Access Compliance Report Public Rights-of-Way (Curb Ramps)

Intersection ID: 11467 Main Street: WALNUT AV **Cross Street: LELA_AV** Location: N ADA ID: 16A587F99247 Ramp Type: Perp Initial Pass/Fail: Fail **Overall Compliance: No Severity Score:** 10

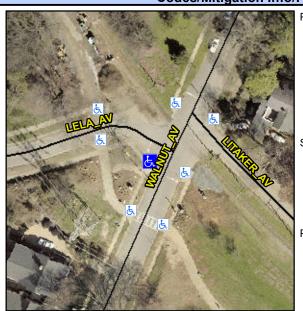
WALNUT AV Street 1 Name Stop Condition-Street 2 StopSign Street 2 Name N/A Stop Condition-Street 1 N/A Possible Solutions: Remove & Replace Entire Ramp. Surveyor Notes: N/A PROW/ADA: Not Found, R304.5.1, R304.5.3

Field Measurements/Component Compliance						
Compl	iance Description	Data	Comp	liance	Description	Data
N/A	Ramp Length (in)	87.0	Yes	Ram	Slope (%)	7.1
No	Ramp Width (in)	47.5	No	Ramp	XSlope (%)	2.3
N/A	Flare Type LT	N/A	N/A	A Flare Type RT		N/A
N/A	Flare Slope LT (%)	N/A	N/A	Flare	Slope RT (%)	N/A
N/A	Flare Traversable LT?	N/A	N/A	Flare Traversable RT?		N/A
N/A	Landing Length (in)	N/A	N/A	DWS	Provided?	N/A
N/A	Landing Width (in)	N/A	N/A	DWS	Contrast?	N/A
N/A	Landing Slope (%)	N/A	N/A	DWS	Length (in)	N/A
N/A	Landing X Slope (%)	N/A	N/A	DWS	Full Width?	N/A
N/A	Landing Curb? (Y/N)	N/A	N/A	DWS	Offset (in)	N/A
N/A	Shared Landing?	N/A				
N/A	Gutter Ponding?	Yes	N/A	Gutte	r Slope (%)	N/A
N/A	Gutter Lip Ht (in)	1.0	N/A	Gutte	r X Slope (%)	N/A
N/A	Painted X Walk1?	No	N/A	Paint	ed X Walk2?	N/A
	X Walk 1 Direction	To SE		X Wa	lk 2 Direction	N/A
N/A	X Walk 1 Width (in)	N/A	N/A	X Wa	lk 2 Width (in)	N/A
	X Walk 1 Slope (%)	6.3		X Wa	lk 2 Slope (%)	N/A
